Abnormal Squeak Noise From Rear Suspension Over Uneven Roads

REVISION NOTICE

The information contained in this bulletin supersedes Service Bulletin No. T-SB-0016-16.

Figure 1.

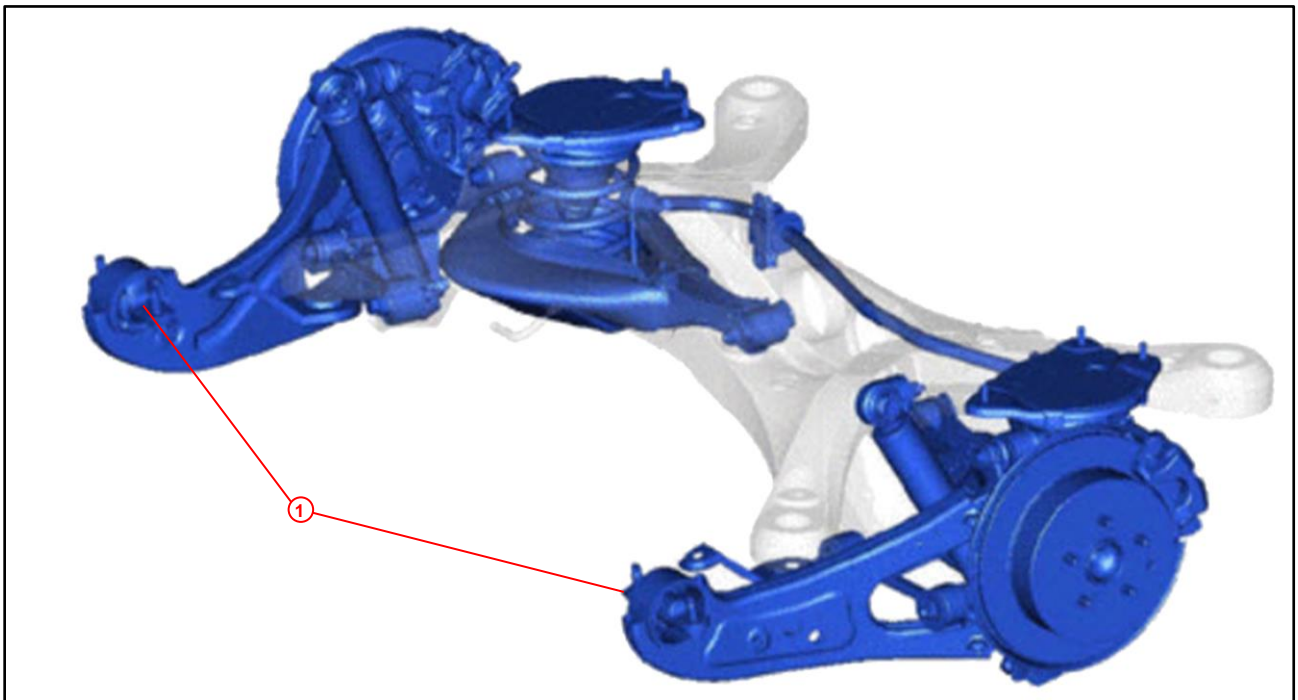
Some 2014 – 2018 model year Highlander and Highlander HV vehicles may exhibit an abnormal squeak noise from the rear suspension. This condition may be more noticeable in colder, ambient temperatures and may occur when traveling over uneven roads or when the vehicle comes to a complete stop. The abnormal noise may be caused by the rear trailing arm bushing. An updated rear trailing arm assembly is available. Follow the Repair Procedure below to address this condition.

Figure 2. LH Side

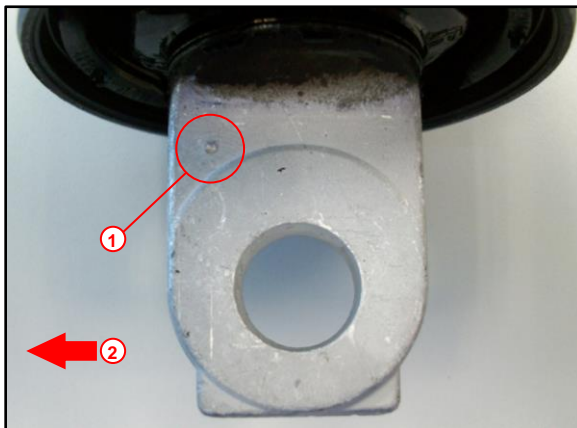
2. BEFORE installing NEW parts, confirm the identification mark as shown. If this mark is NOT present, the part is incorrect and SHOULD NOT BE INSTALLED.

The identification mark on the NEW part faces the outside of the vehicle.
